Change Order No. 3

Project: Lincoln Street Improvement Project	Owner: State of Wyoming	Owner's Contract No.:E0624
Contract: Lincoln Street Improvement Project		Date of Contract: July 3, 2024
Contractor: High Country Construction		Engineer's Project No.: 17063

Work Change Directive

**LINCOLN STREET WATER REPAIR
 STREET RECONSTRUCTION PROJECT
 PLAN SHEET - STA 35+00 TO 40+00**

SHEET NO. **P-8**

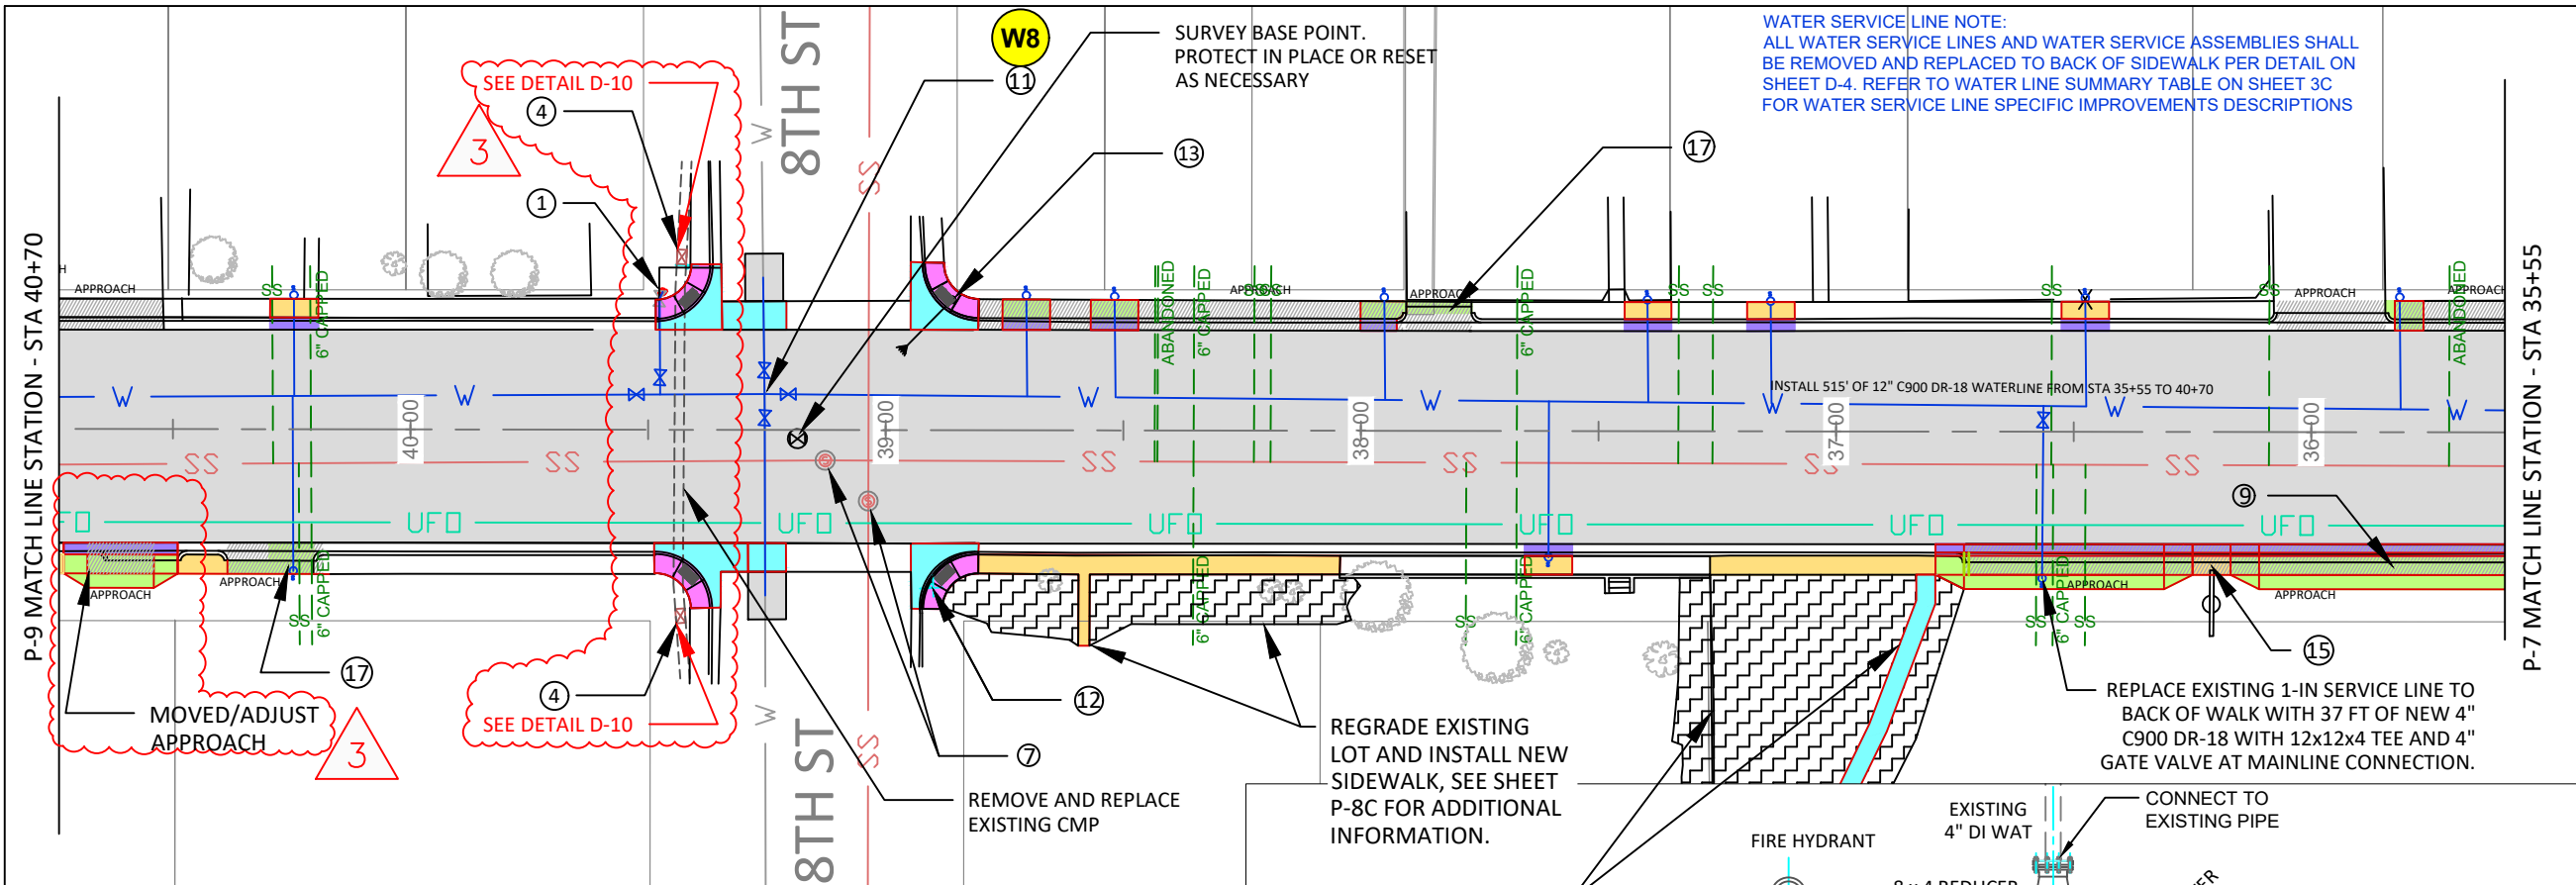
- 1) Add (3) sewer services and (4) water services on 600 block. - To be paid according to CO#2 Pricing. These services were already counted in CO#2, but not yet delineated.
- 2) Adjust dimensions and/or relocate two (2) approaches on 800 block. – To be paid under bid unit price items 9,21,24,25,& 26 per field measured quantities.
- 3) Install irrigation box and pipe components according to clarifications detailed in attached revisions. – Notify engineer of any expected changes in price.

W8 LINCOLN STREET/8TH STREET
 SCALE: NTS

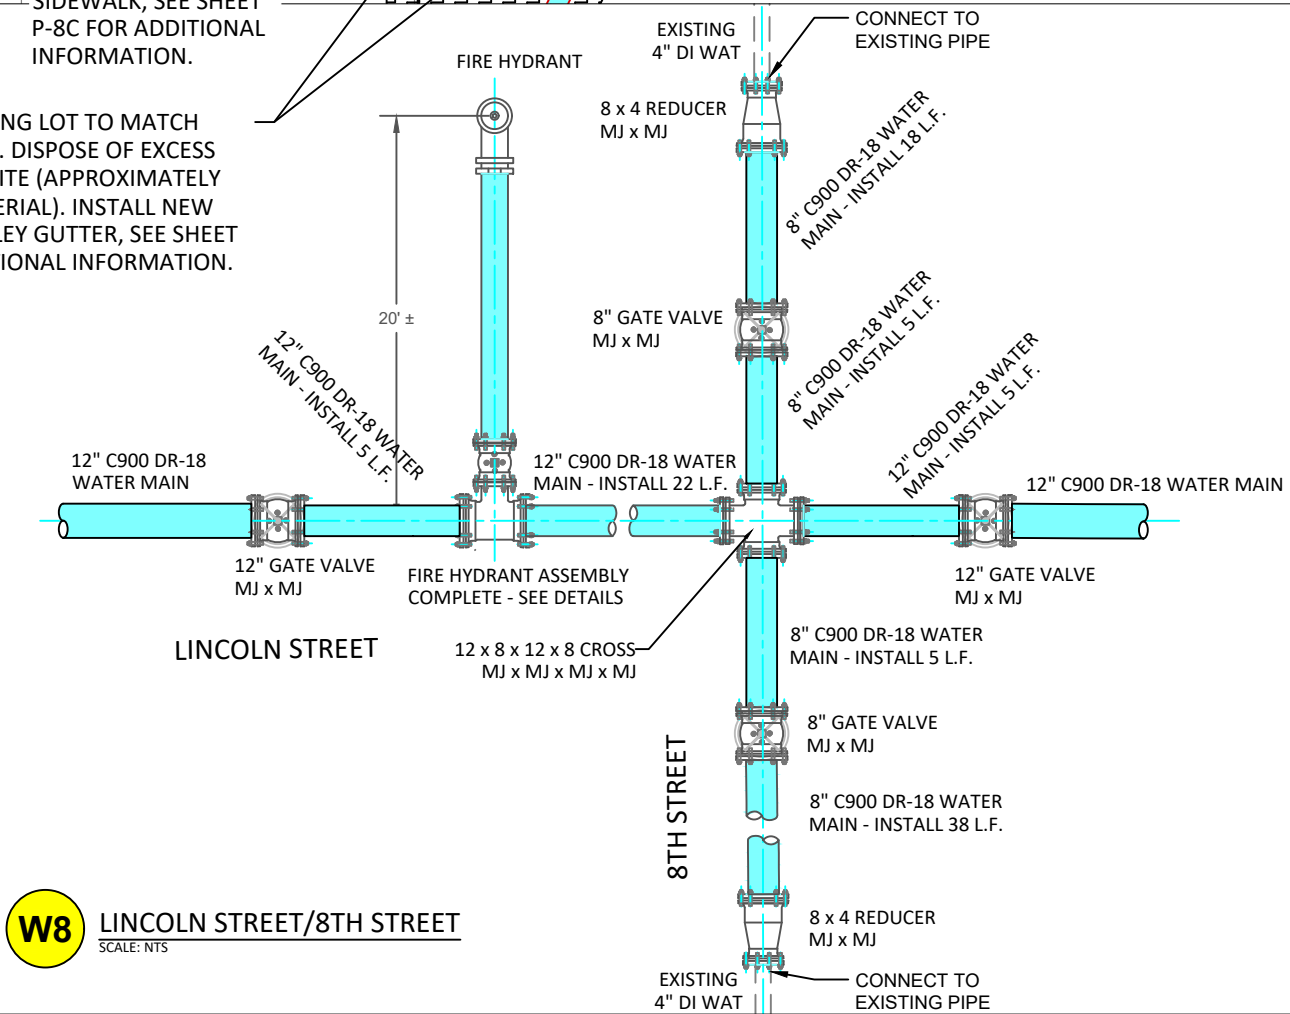
REGRADE PARKING LOT TO MATCH NEW SIDEWALK. DISPOSE OF EXCESS MATERIAL OFFSITE (APPROXIMATELY 150 CY OF MATERIAL). INSTALL NEW CONCRETE VALLEY GUTTER, SEE SHEET P-8B FOR ADDITIONAL INFORMATION.
